SUBJECT: Forwards open items from Structural Engineering Branch
 811005-08 meeting in Woodbury, NY.

Subject: NUCLEAR PROJECT NO. 2
OPEN ITEMS FROM SEB MEETING

Attached are sixty copies of the open items from the Structural Engineering Branch meeting held in Woodbury, New York, October 5 - 8, 1981.

WNP-2
NRC-SEB MEETING

NOTE: ALL ELEMENTS ARE WATER.

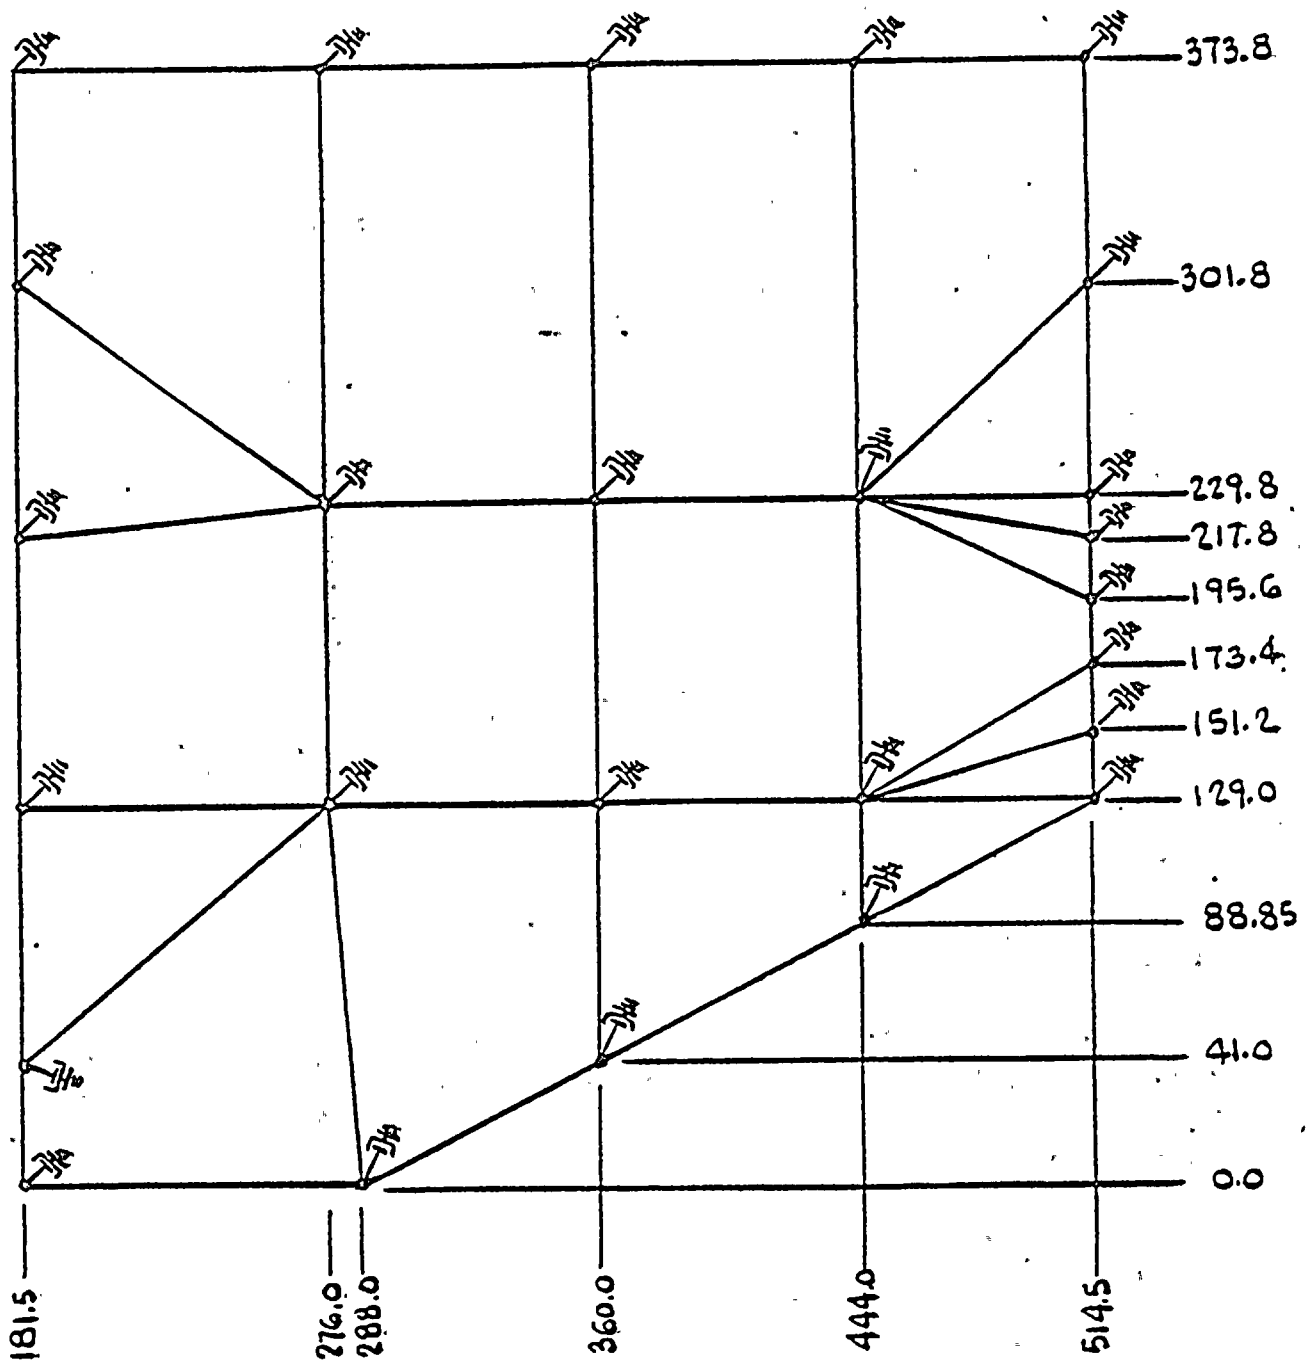
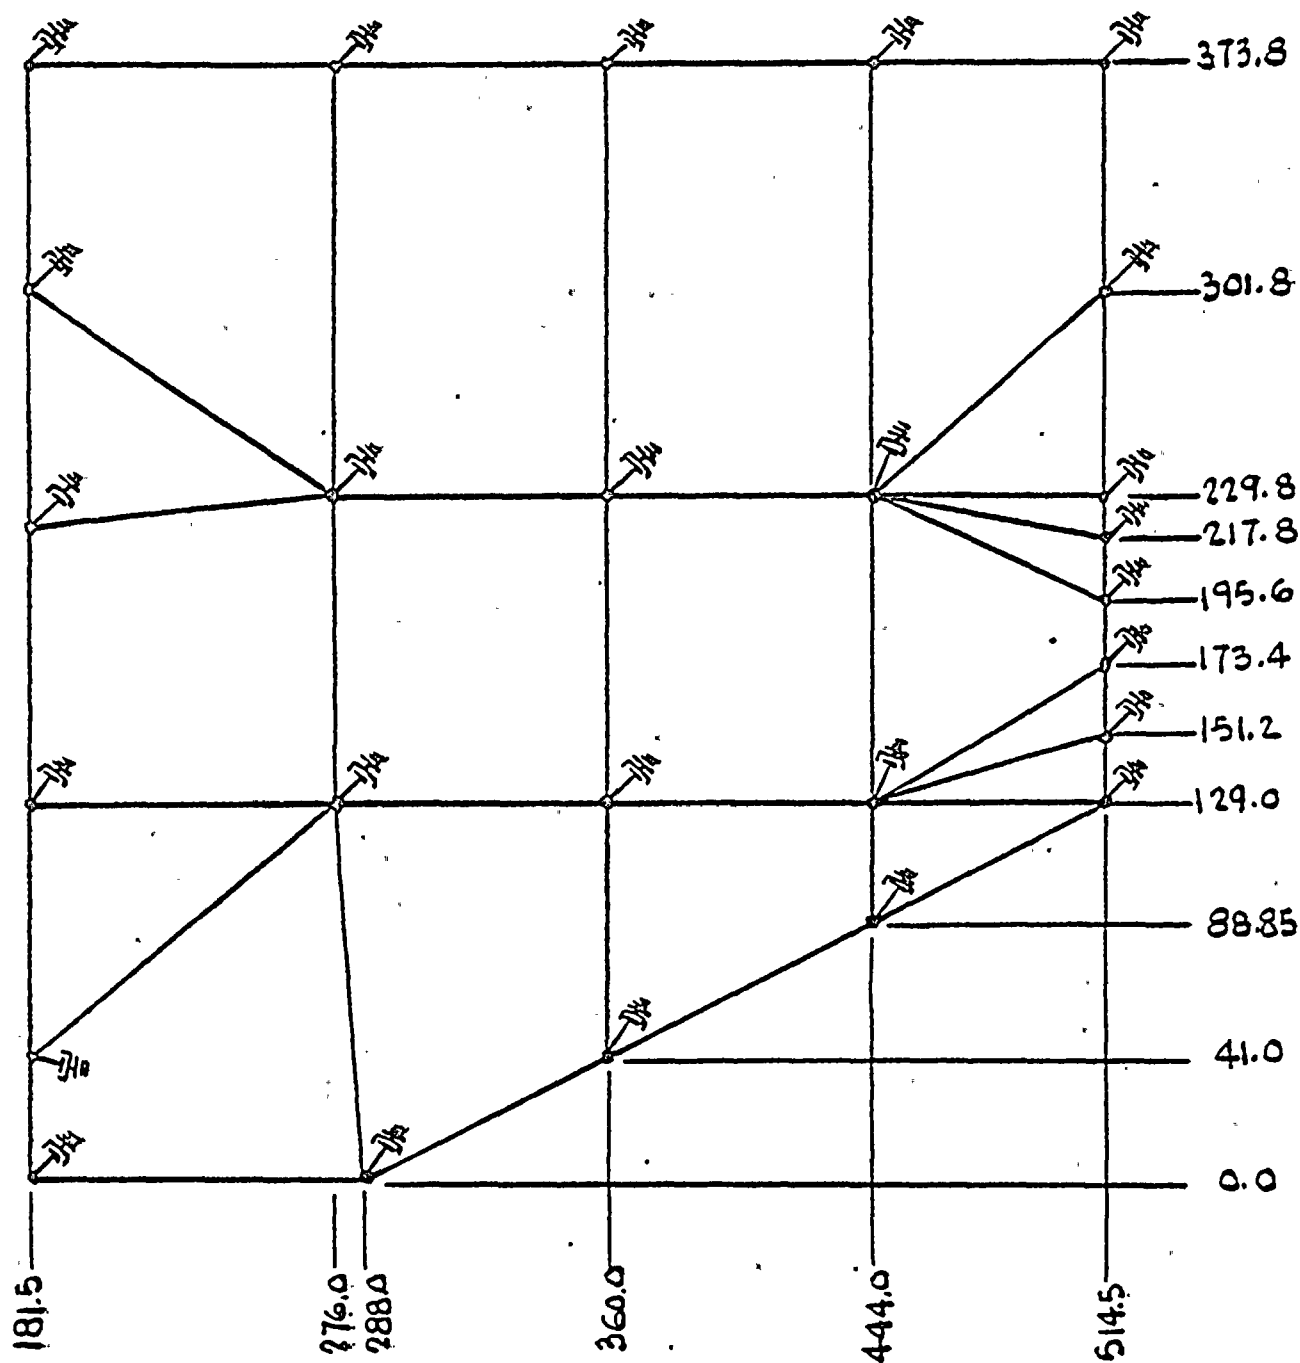
In the theoretical formulation of the equation for the fluid-structure interaction analysis as indicated in Section 5.2 of the report, a so called dynamic stiffness matrix is defined in terms of M_s , M_a , C_s and K_s matrices. Provide a discussion how the structural damping matrix C_s is established, and why the natural frequency of the structure is not involved in the formulation. In the model shown in Figure 5-4, no water is indicated, therefore, how M_a is considered? Provide a model used in the analysis which includes all the physical elements as contained in equation 5.3 of the report. How do you verify the validity of your theoretical formulation?

Different element damping matrices C_s^n can be assembled using the conventional assembling finite element method technique to form the total structural damping matrix C_s . Since C_s^n is formed for each individual element, it is non-proportional damping matrix thus it is independent from the structural natural frequencies. It insures that the loss of energy due to damping in each individual element is constant over all frequencies, Ref. 130.073.1.

The hydrodynamic added mass matrix M_a was computed using the hydrodynamic finite element model of Figs. 5.3 and 5.4 of B&R chugging report. The theoretical formulation of the model is described in detail in Appendix 5.1 of Ref. 130.073.2. The theoretical formulation was verified against the program NASTRAN, Ref. 130.073.3. Also, in Ref. 130.073.2 it was shown that this formulation can predict quite well the general behavior of the 4T test facility during chugging tests.
